Minutes of 94th PCC Meeting

EASTERN REGIONAL POWER COMMITTEE

MINUTES OF 94TH PROTECTION SUB-COMMITTEE MEETING HELD ON 28.09.2020 AT 10:30 HOURS

SLD OF BIHARSHARIF GSS

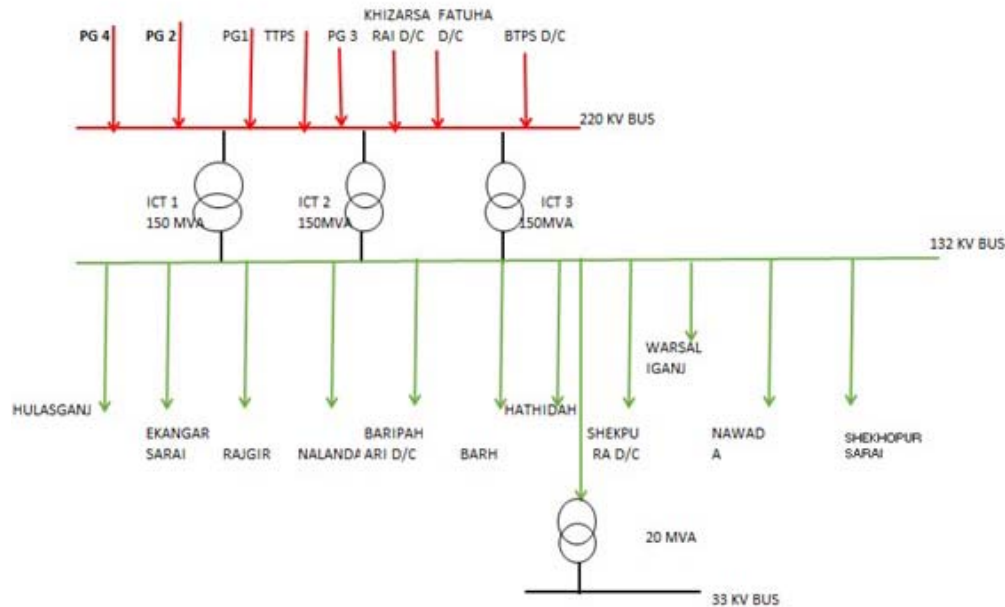
BSPTCL informed that Y phase Conductor of 220 kV Bihar Sharif – TTPS S/C snapped at location No. 496-497 and fell on 132 kV Bihar Sharif – Sheikhpura D/C at tower loc no. 10 from Bihar Sharif. BSPTCL explained that 220 kV Bihar Sharif – TTPS S/C line was tripped from Bihar Sharif end on backup overcurrent E/F protection as distance relay did not pickup the fault and TTPS end tripped on zone 2. 400/220 kV ICT 2 & 3 at Bihar Sharif were tripped from LV side and 220/132 kV ICT 1, 2 & 3 were tripped on OSR protection. 132 KV Bihar Sharif – Sheikhpura D/C lines tripped from Bihar Sharif end on zone 1 and there was no tripping from Sheikhpura end as the line was radially connected with Bihar Sharif.

PCC opined that distance protection at Bihar Sharif might not pickup the fault in 220 kV Bihar Sharif – TTPS S/C due to close in fault and the line was tripped from Bihar Sharif on backup protection.

PCC observed the following and advised BSPTCL to take the corrective action:

- BSPTCL should carry out proper maintenance of the transmission system to avoid snapping of conductors.*
- 400/220 kV ICT 2 & 3 at Bihar Sharif should not trip from backup overcurrent protection of LV side as the fault got cleared within 400 ms. BSPTCL review the relay settings in coordination with Powergrid.*
- Healthiness of the transformers 220/132 kV ICT 1, 2 & 3 should be checked as the transformers tripped on Oil Surge Relay protection.*

RELEVANT SYSTEM SLD:

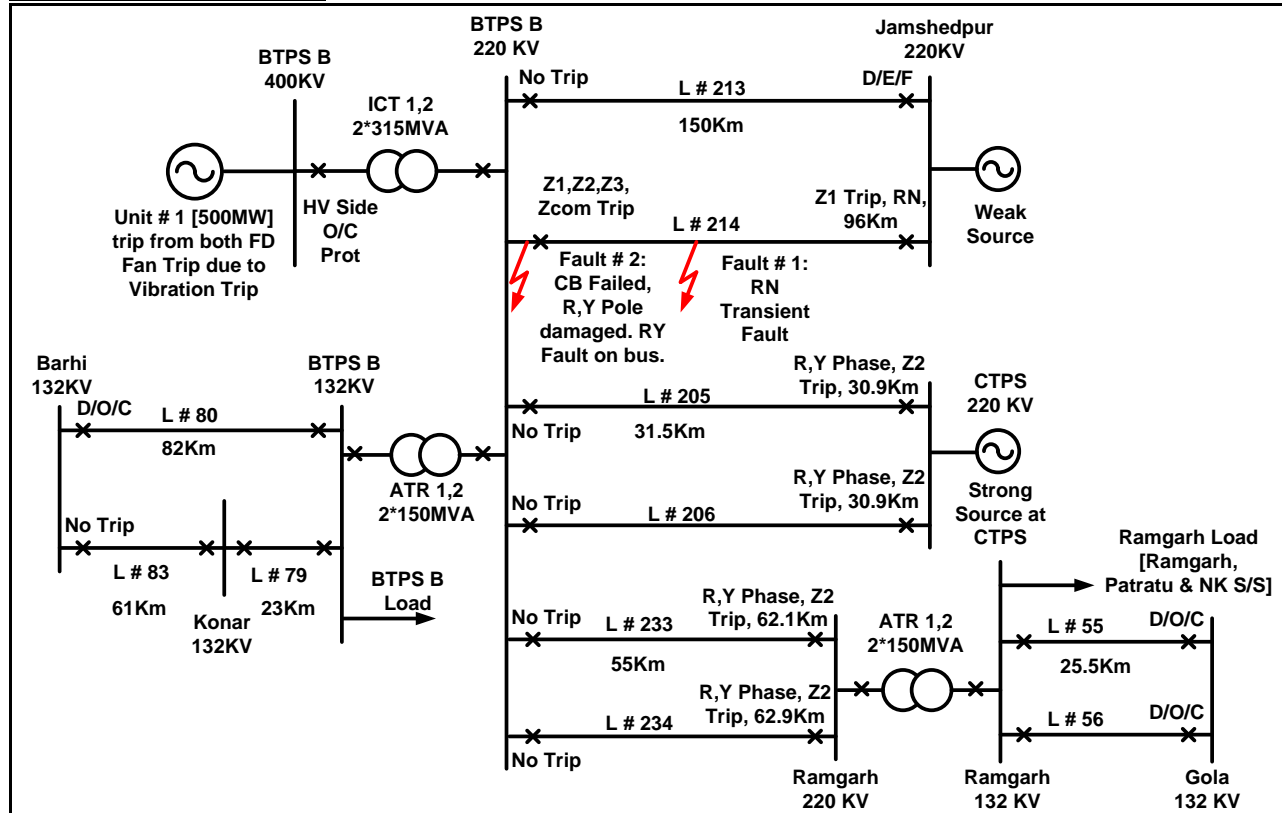
1. The CT terminal connections of CT Switching relays of BTPS CTPS Ckt 2 [L# 206] were found in damaged and burnt out condition leading to mismatch of current in Main Bus Zone 2. The CT

Switching relays of ATR 1 panel was found in operated condition for both buses which had shorted the Bus Zone 1 & 2 CT circuits thereby extending the mismatch to Bus Zone 1 too which had caused Bus Wire supervision to be operated for both Bus Zones.

2. Both the above discrepancies were rectified and busbar protection for both buses normalized.
3. The settings of ATR O/C relays were checked by fault studies and found to be O.K i.e. due to lack of fault current from 132KV side they would not pick up. Thus any tripping from 132KV side would occur only after majority of 220KV sources trip but before such tripping occurs the 132KV lines would trip due to shift of load current.
